# Access Compliance Report

Intersection ID: 10020687	Main Street: BEAM_RD	Cross Street: N/A	Location: NE
ADA ID: D7E3DA23F434	Ramp Type: BlendTrans1	Initial Pass/Fail: Pass	Overall Compliance: No
		Severity Score: 7.75

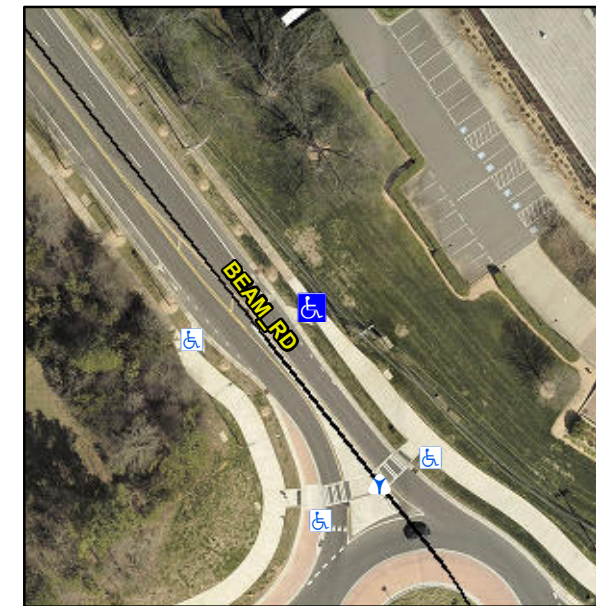
**Not Found, R304.5.3, R305.2, R302.7.2**

Compliance	Description	Data	Compliance	Description	Data
N/A	Ramp Length (in)	96.0	Yes	BlendTrans Slope (%)	3.9
Yes	Ramp Width (in)	68.0	No	BlendTrans XSlope (%)	2.3
N/A	Flare Type LT	None	N/A	Flare Type RT	None
N/A	Flare Slope LT (%)	N/A	N/A	Flare Slope RT (%)	N/A
N/A	Flare Traversable LT?	N/A	N/A	Flare Traversable RT?	N/A
Yes	Landing Length (in)	75.0	Yes	DWS Provided?	Yes
Yes	Landing Width (in)	108.0	Yes	DWS Contrast?	Yes
Yes	Landing Slope (%)	0.3	Yes	DWS Length (in)	24.0
Yes	Landing X Slope (%)	1.7	Yes	DWS Full Width?	Yes
N/A	Landing Curb? (Y/N)	No	No	DWS Offset (in)	70.0
N/A	Shared Landing?	No			
Yes	Gutter Ponding?	No	Yes	Gutter Slope (%)	4.1
No	Gutter Lip Ht (in)	0.5	Yes	Gutter X Slope (%)	1.4
N/A	Painted X Walk1?	No	N/A	Painted X Walk2?	N/A
	X Walk 1 Direction	To SW		X Walk 2 Direction	N/A
	X Walk 1 Width (in)	N/A		X Walk 2 Width (in)	N/A
	X Walk 1 Slope (%)	3.0		X Walk 2 Slope (%)	N/A
	X Walk 1 X Slope (%)	1.1		X Walk 2 X Slope (%)	N/A

N/A	Ramp inside XWalk1?	N/A	N/A	Ramp inside XWalk2?	N/A
	Road Slope (%)	1.1		Clear Space?	Yes
	Road X Slope (%)	3.0	N/A	Clear Space to XWalk (in)	N/A
Yes	Any Obstructions?	No	Yes	Storm Grate/Utility Hazard?	No
	Obstruction Type			Storm Grate/Utility Type	
		N/A			N/A
			Yes	Surface Condition? (G/P)	Good
			No	Curb Slope (%)	10.0

**Remove & Replace Curb Ramp With Two New Directional Ramps or Equivalent.**
